# IECC - Residential IRC - Energy

## 2016 GROUP B PUBLIC COMMENT AGENDA

OCTOBER 19 - OCTOBER 25, 2016  
KANSAS CITY CONVENTION CENTER  
KANSAS CITY, MO

FIGURE 1: OPTIONS FOR INSTALLING INSULATION IN CEILING, ABOVE OR BELOW ROOF SHEATHING

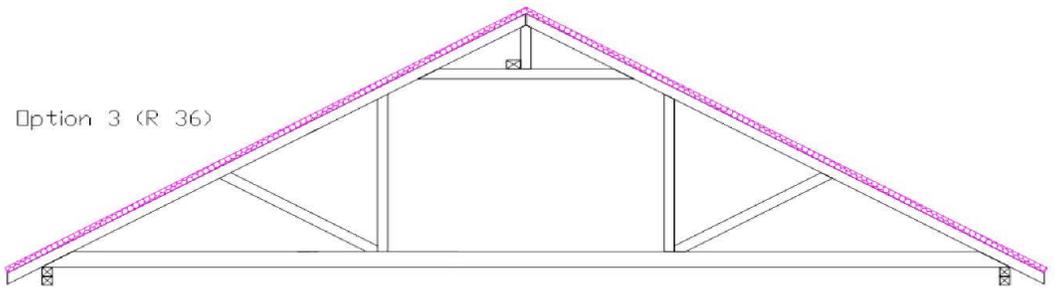
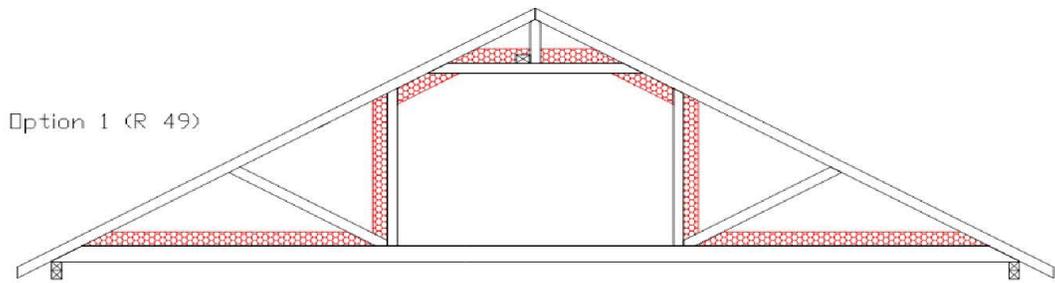
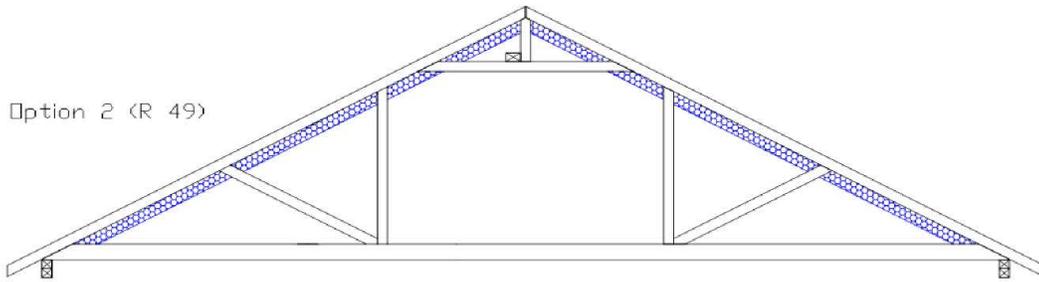
**Commenter's Reason:** This proposed change helps to clarify the requirements for insulation installed either in the ceiling or at the roof deck. As shown in Figure 1, ceiling insulation can be installed directly above the ceiling gypsum (option 1), below the roof sheathing (option 2) or above the roof sheathing (option 3). The R-value required for continuous insulation in option 1 is less than options 2 or 3 because of the reduced thermal bridging.

The prescriptive R-Value table in the IECC contains an option for traditional ceiling insulation installed between and around roof truss assemblies, but does not contain an R-Value option for continuous insulation installed above the roof sheathing without ceiling insulation. With the increase in the use of continuous insulation in roof assemblies, whether through advanced roof framing, SIPS panels, or other systems, it is appropriate to include that option, with values that meet the U-Factor requirements in Table R402.1.4, in Table 402.1.2.

**Figure 1: 2011 Electricity Flow (in Quadrillion Btu)[ii]**

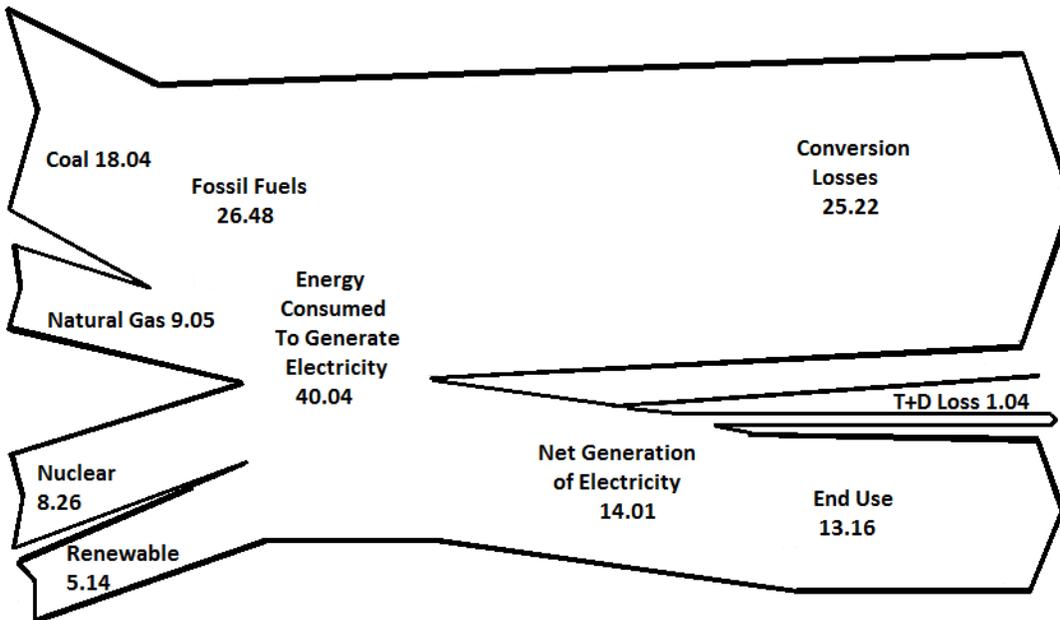
The EIA Electricity Flow chart (Figure 1), upon which the source energy metric is based, is designed to illustrate the relative contribution of energy by fuel type into the electrical system. In order to illustrate the relative portion of non-fossil fuel in the grid, an artificial conversion for electricity generated by non-fossil fuels is used. For renewable energy, for example, a fossil fuel heat rate above the average for natural gas plants is used, see Figure 2. However, those artificial conversions are not appropriate for the purposes of illustrating relative resource efficiency or environmental performance of the various non-fossil fuels. The conversions are not based on any practical science and are contradictory to the policy objectives that the source energy metric is designed to address.

Figure 2.  
1000 S.F.  
1 STORY  
30 FT RADIAL ALLOWANCE  
ALL PLUMBING FIXTURES IN DWELLING COMPLY

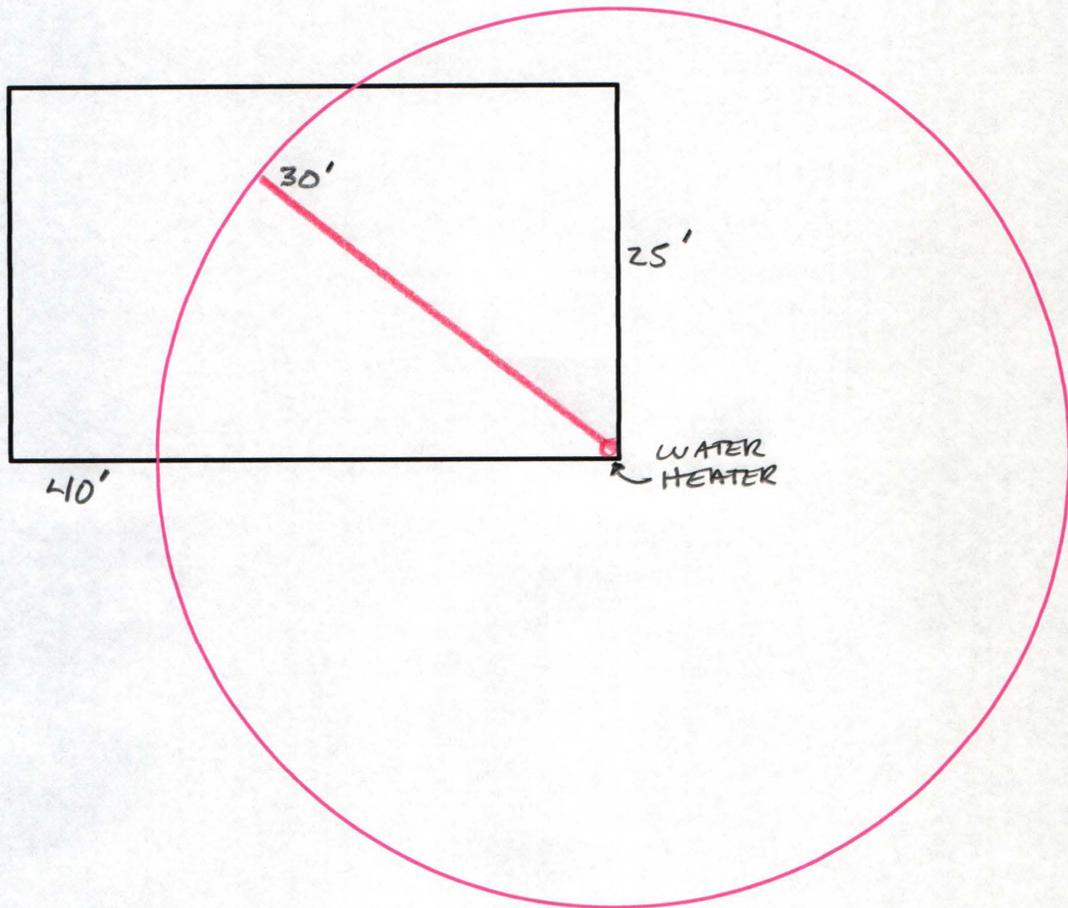
**Figure 2.** A second illustration of the same sized small home shows the effect of moving the hot water heater to a more central location. In Figure 2, the position of the hot water heater is at a more central point along an exterior wall. This entire home falls within the 30-foot arc, and the plan would be compliant for all possible locations of hot water outlets within this home.

Figure 3.

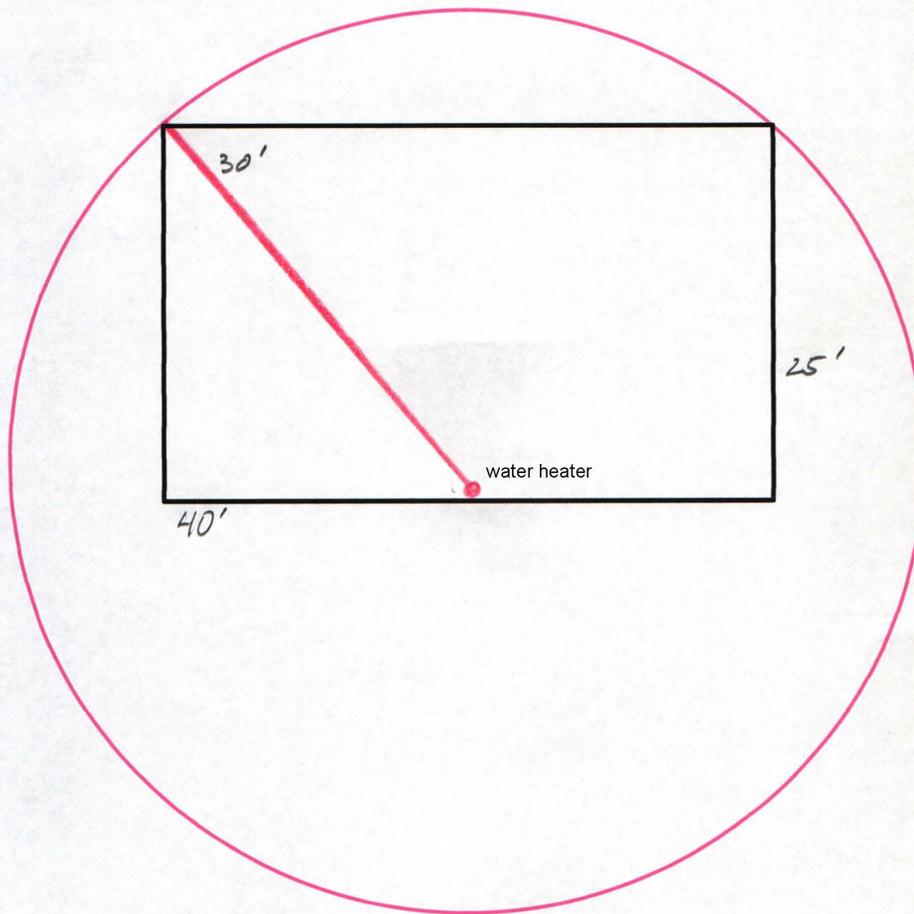
**Figure 3.** This third illustration shows the plan for a somewhat larger one-story home, with 2,200 square feet. In Figure 3, as per the values in proposed Table R403.5.X.2, the straight-line distance allowed between the water heater and the outlet of a hot water fixture listed in the first paragraph of the proposal is 50 feet. Here, all hot water outlets fall within the 50-foot arc, so

the plan complies. Note, however, that if the master bath had been placed in the location of the sitting room, it is possible that one or more hot water outlets would have fallen outside the 50-foot arc, and such a plan would not comply. But some adjustment of fixture locations within the master bath by the designer would likely have brought the plan into compliance.

Figure 4, sheet 1

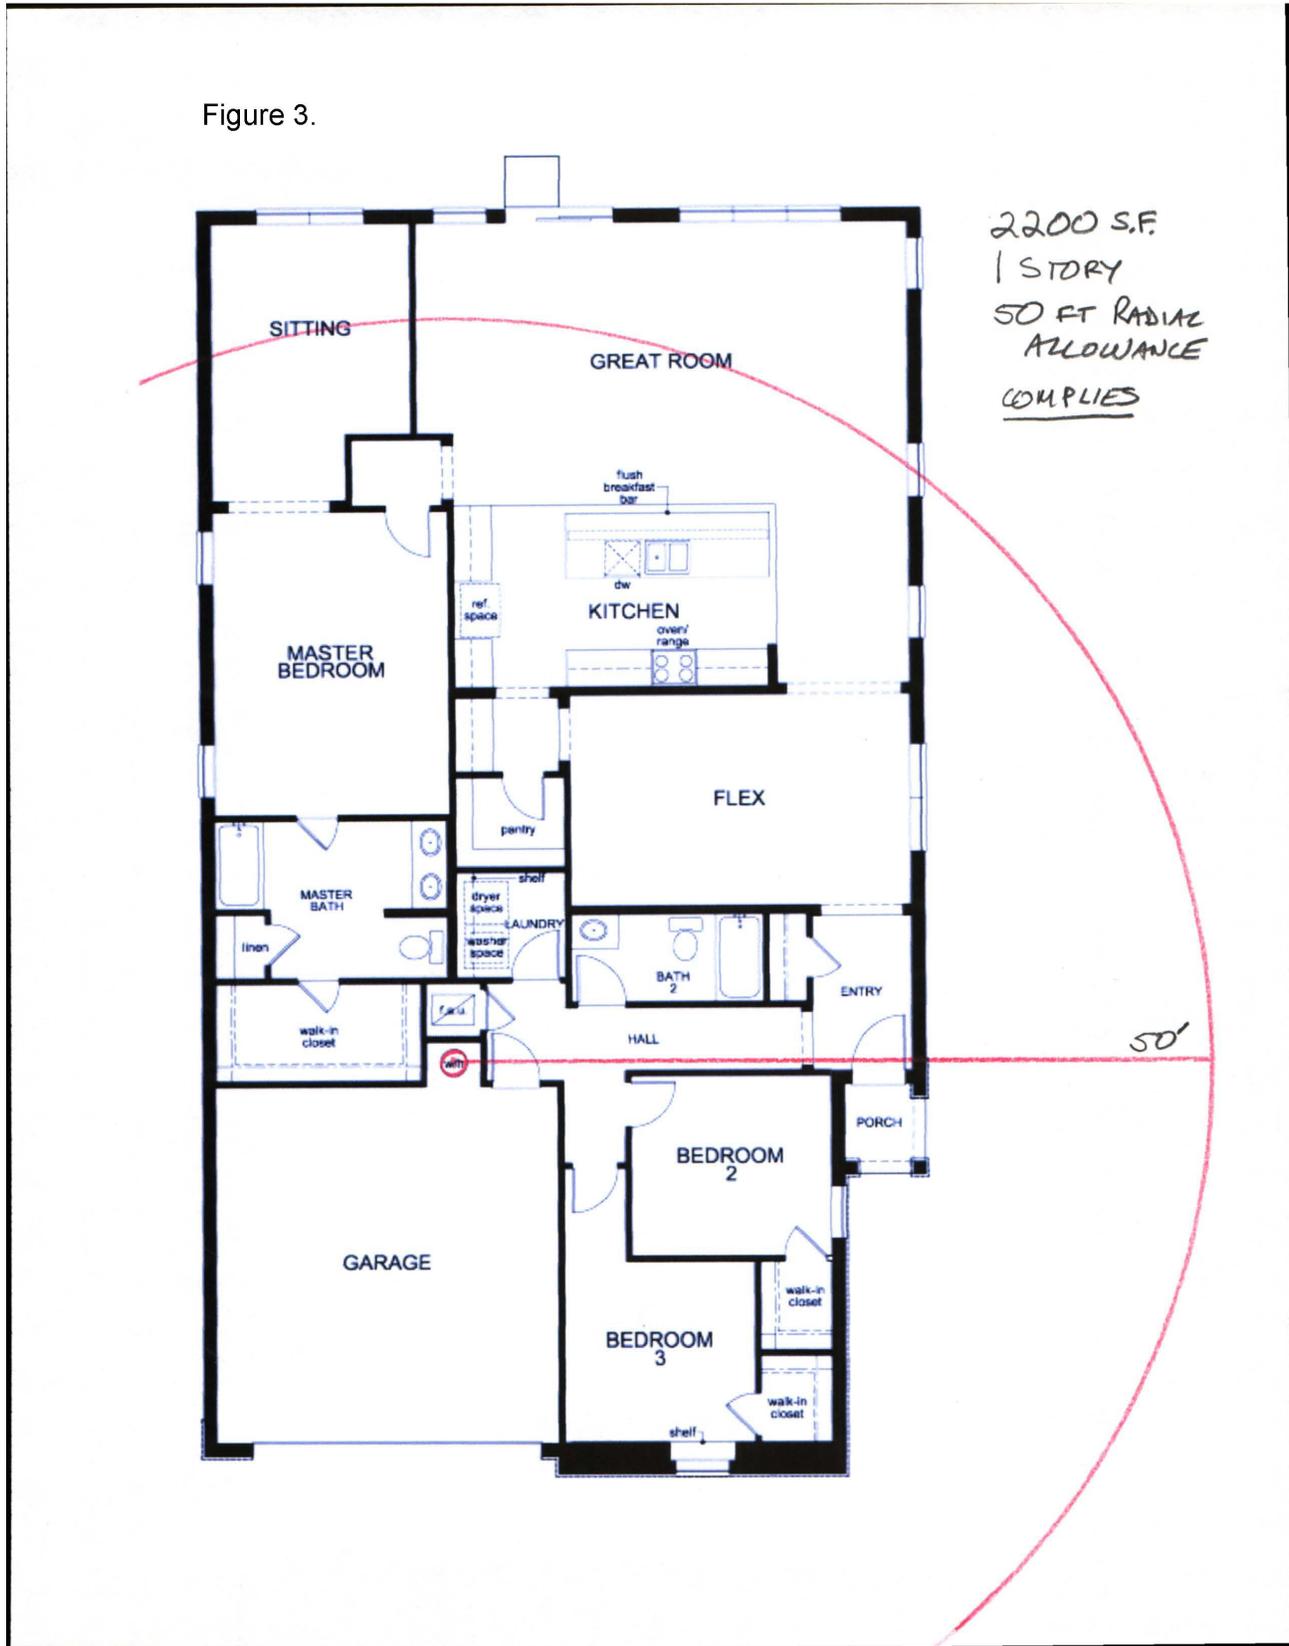
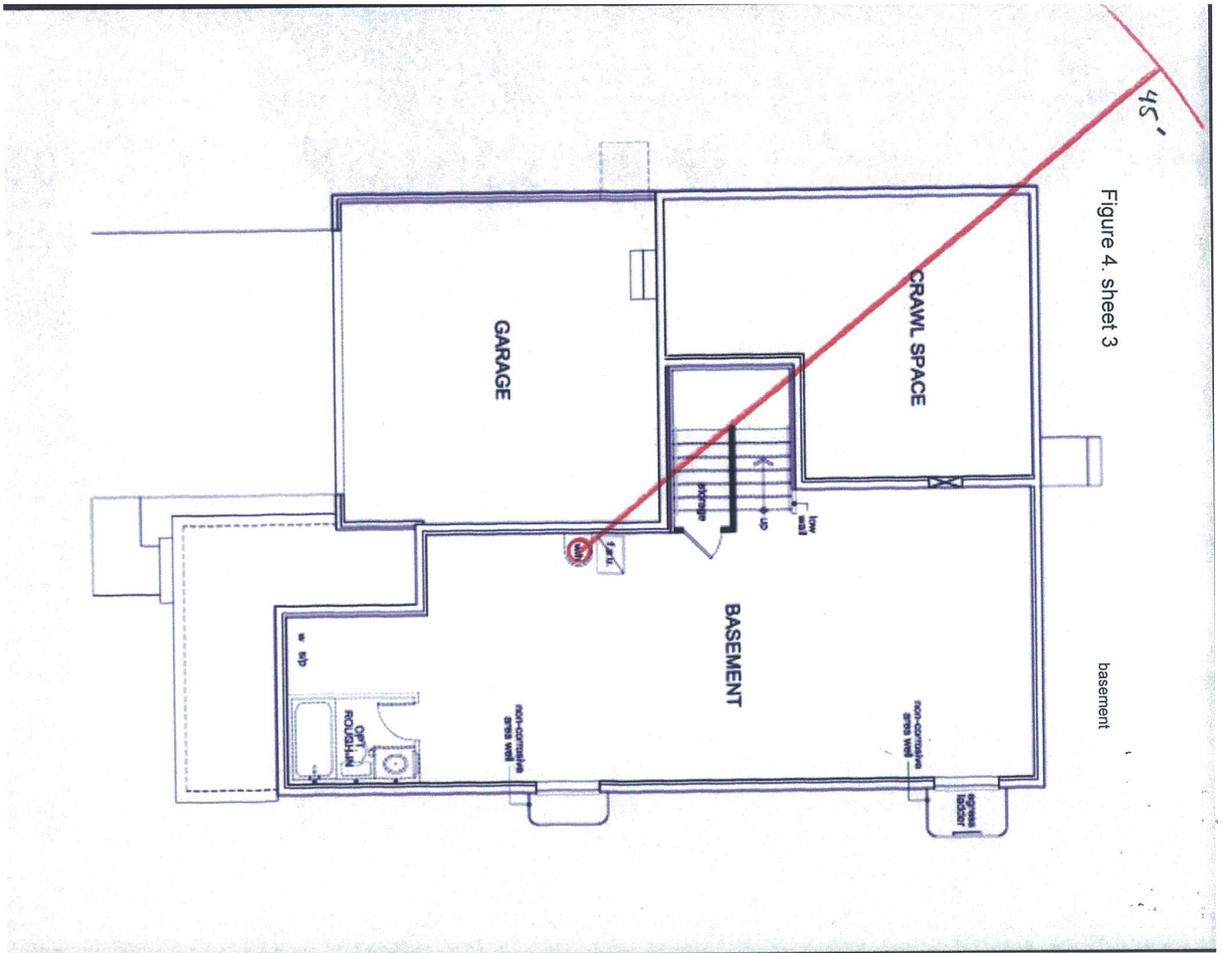
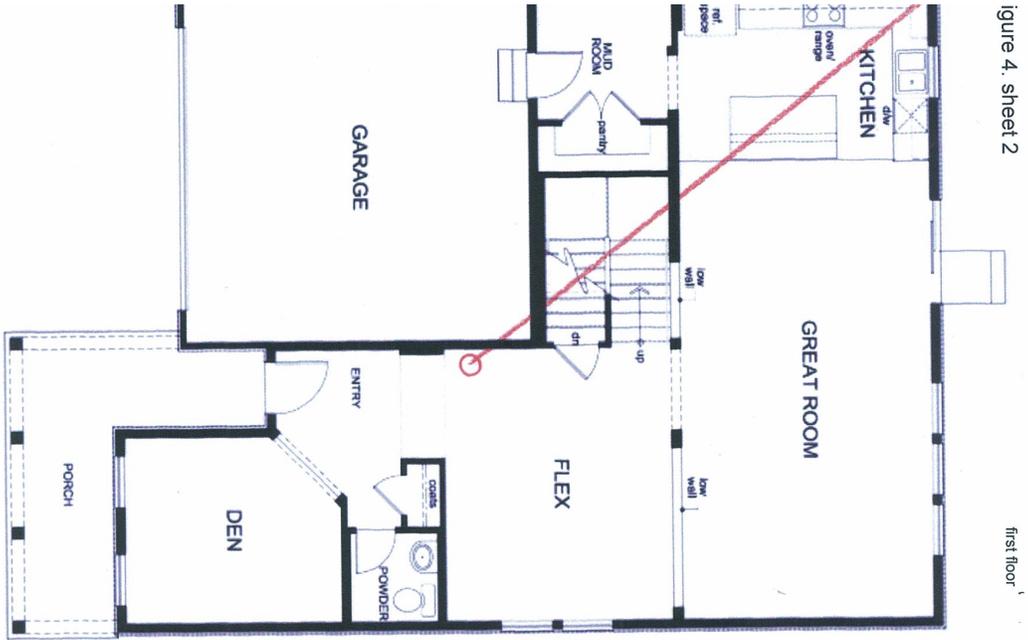
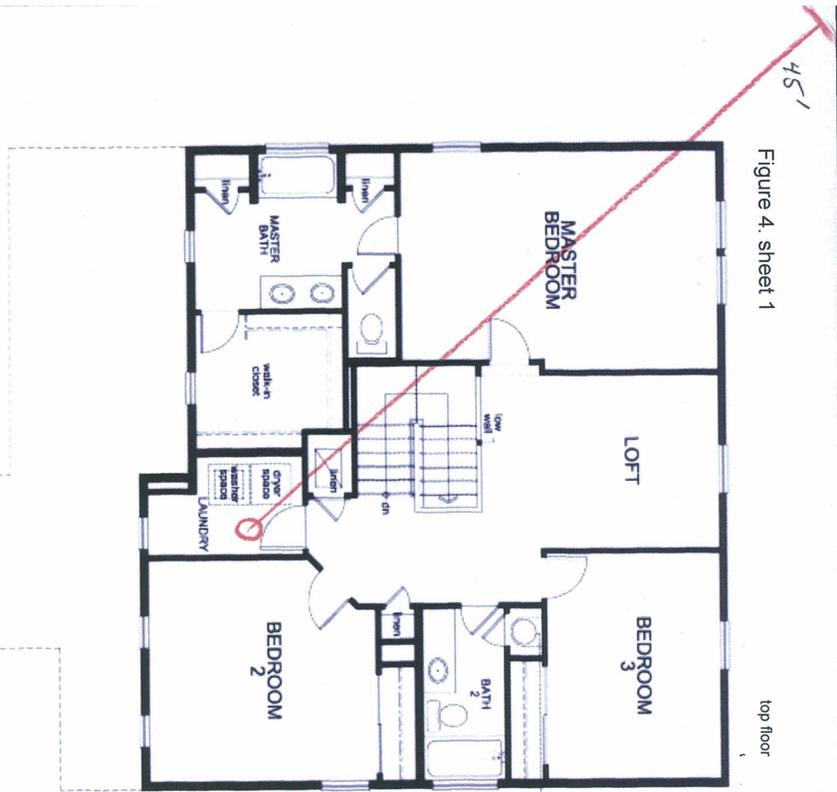
**Figure 4, Sheets 1, 2, and 3.** A fourth illustration (on 3 sheets) demonstrates the application of the proposal to multi-story homes, in this case, a home of 2,600 square feet and a maximum straight-line distance allowance of 45 feet. In this example, the hot water heater is located in the basement, as shown in Figure 4, Sheet 3. Section R403.5.3.2 of the proposal specifies that the location of the hot water heater "shall be translated vertically to each floor on which a fixture served by such water heater is located." In other words, the maximum straight-line distance is applied separately on each floor, measured from a point on each floor that is directly above the location of the hot water heater in the basement. In Figure 4, Sheets 2 and 1, one can see that the point of measurement on both the first and second floors is the same position in the plane of each floor as the position of the hot water heater in the plane of the basement. In this example, this relatively compact house design easily complies with the 45-foot maximum distance for a multi-story home of this square footage.

2600 S.F.  
 2 STORY ABOVE  
 BASEMENT  
 45 FT RADIANT  
 ALLOWANCE  
 COMPLIES
